PROJECT TITLE: Blanco - <sup>Lamp</sup> Shade Store ZONE ATLAS/DRNG. FILE #: 4-17 <sup>D22</sup> ~~22~~

*D22*  
**RE: RETAIL LAMP STORE (L17-~~17~~). DRAINAGE AND GRADING PLAN FOR  
BUILDING PERMIT APPROVAL. ENGINEER'S STAMP DATED APRIL 30, 1998.**

RE: Retail Lamp Store (L-17/<sup>D22</sup>~~17~~), Grading and Drainage Plan, Dated 3/24/98

RE: DRAINAGE PLAN FOR RETAIL LAMP STORE (L17-<sup>D22</sup>~~EE~~) ENGINEER'S STAMP  
DATED 3/24/98 AND ADDITIONAL INFORMATION SUBMITTED 4/16/98

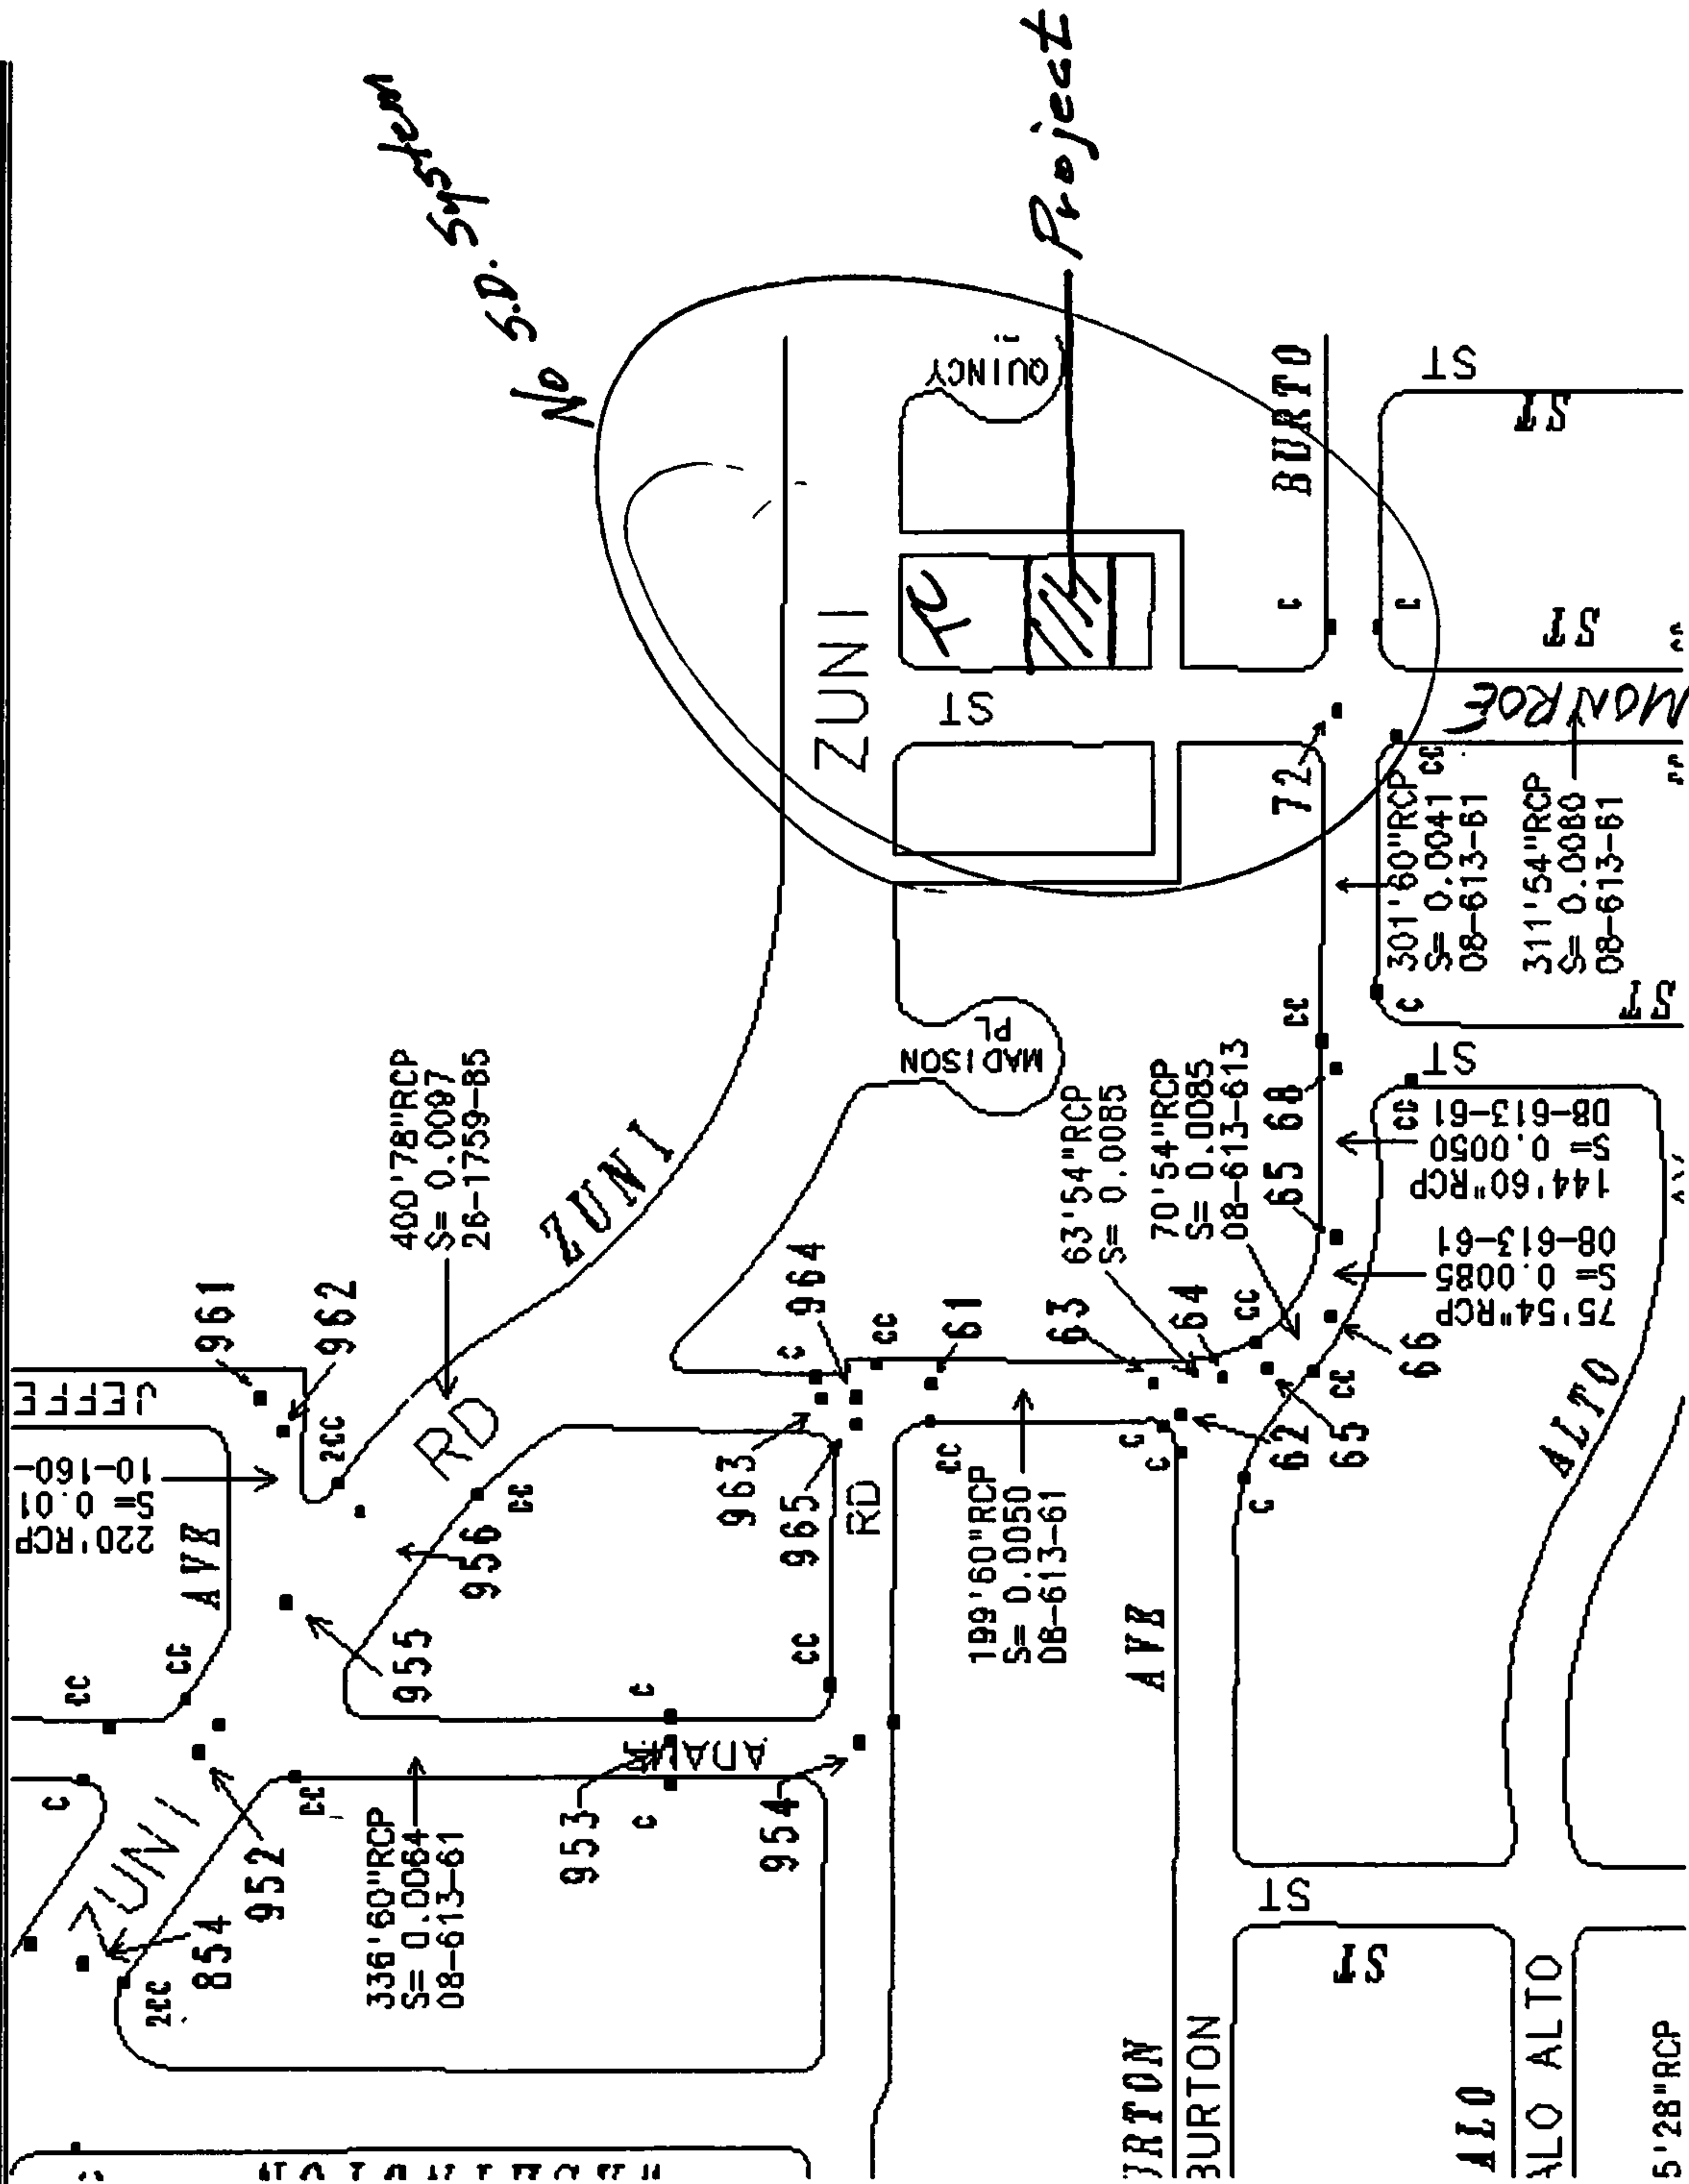
NO credit  
for "ponds"

A-E  
misinterpreted  
letter.  
RE-Data

MUST BE ON PLAN
